AF91.10-U-2101A	Front seat cushion has insufficient side support when driving through turns, front seat cushion cover damaged in the area of the seat cushion adjustment knob	29.4.97
-----------------	---	---------

MODEL 124

P91.10-0544-01

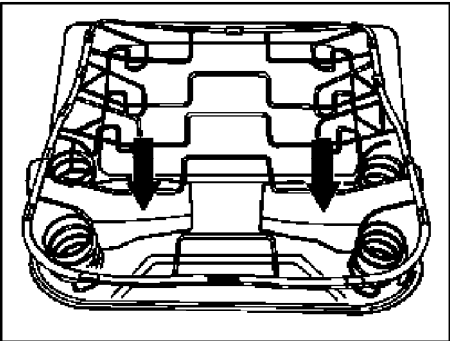
Damage Code	Cause	Remedy	
No Code	<ul style="list-style-type: none"> <li>Insufficient side support of seat cushion frame.</li> <li>With extreme weight on the front seat, the seat cushion cover can be pinched at the front seat tilt adjustment mechanism.</li> </ul>	1    Install two foam block to the seat cushion padding on the left and right side between the two front springs. Part No: 124 910 16 75   <b>Production Phase-In:</b> As of 4/89 production.
